SERVICE BULLETIN

Service Bulletin #: SB03

Title: Engine Instrument Software Update.

Figure 1: EX5000C with Compact Flash Cover

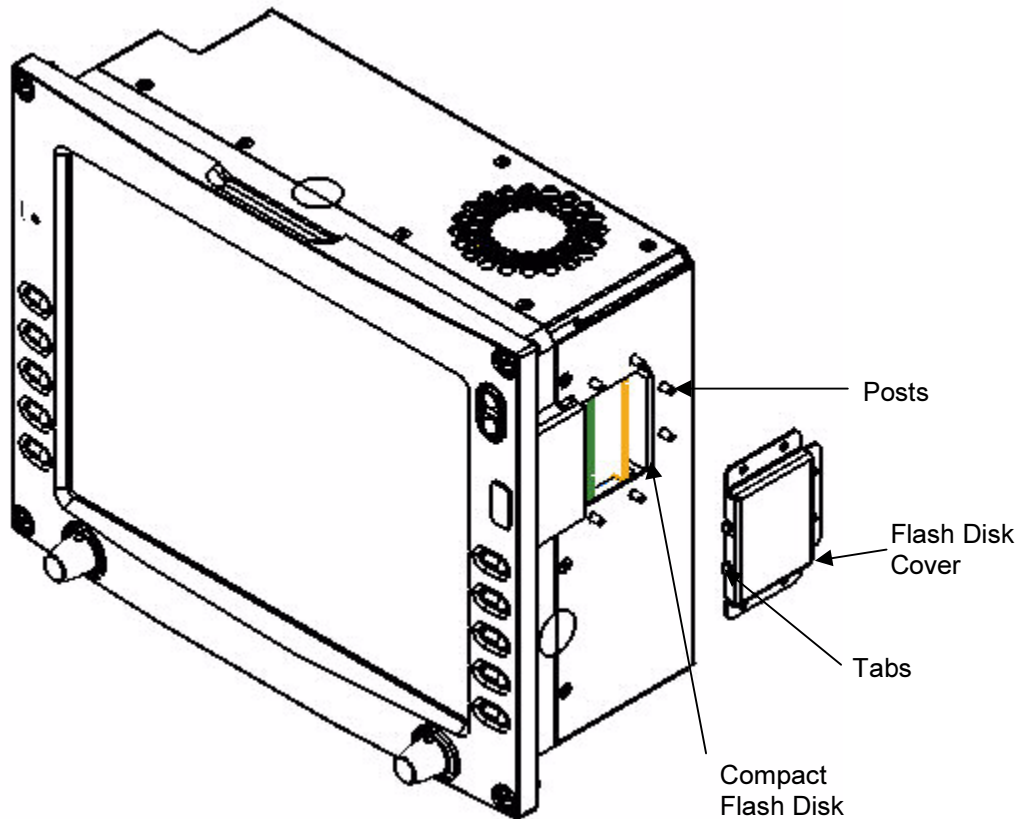
This procedure should be performed on the bench. Ensure NO power is applied to the unit. Refer to Figure 1.

1. Remove the Flash cover by unscrewing the 6 nuts and lifting the cover off the posts.
2. Remove the 530-00112-000 Rev XX (See effectivity/compatibility) compact flash by pulling it from the connector and sliding it out (as shown in Figure 1).
3. Record the serial number of the EX5000C on the removed compact flash and return it to Avidyne Corporation, 55 Old Bedford Road, Lincoln, MA 01773.

Figure 1: EX5000C with Compact Flash Cover

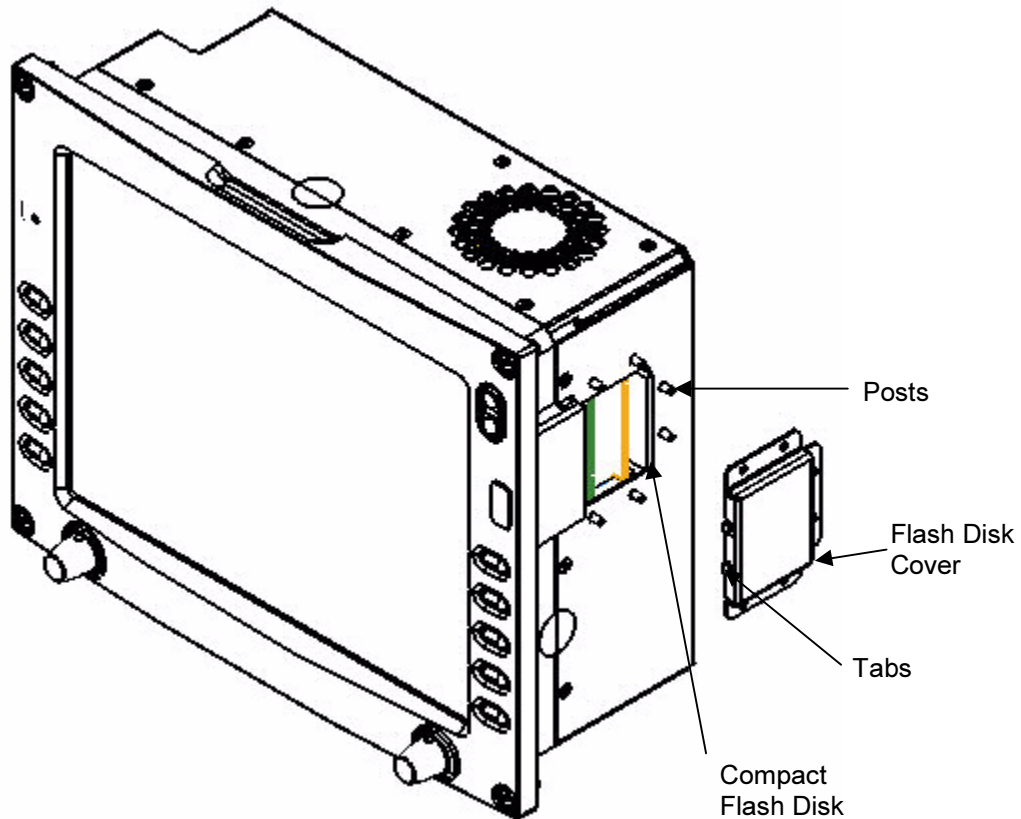
This procedure should be performed on the bench. Ensure NO power is applied to the unit. Refer to Figure 1.

1. Remove the Flash cover by unscrewing the 6 nuts and lifting the cover off the posts.
2. Remove the 530-00112-000 Rev XX (See effectivity/compatibility) compact flash by pulling it from the connector and sliding it out (as shown in Figure 1).
3. Record the serial number of the EX5000C on the removed compact flash and return it to Avidyne Corporation, 55 Old Bedford Road, Lincoln, MA 01773.
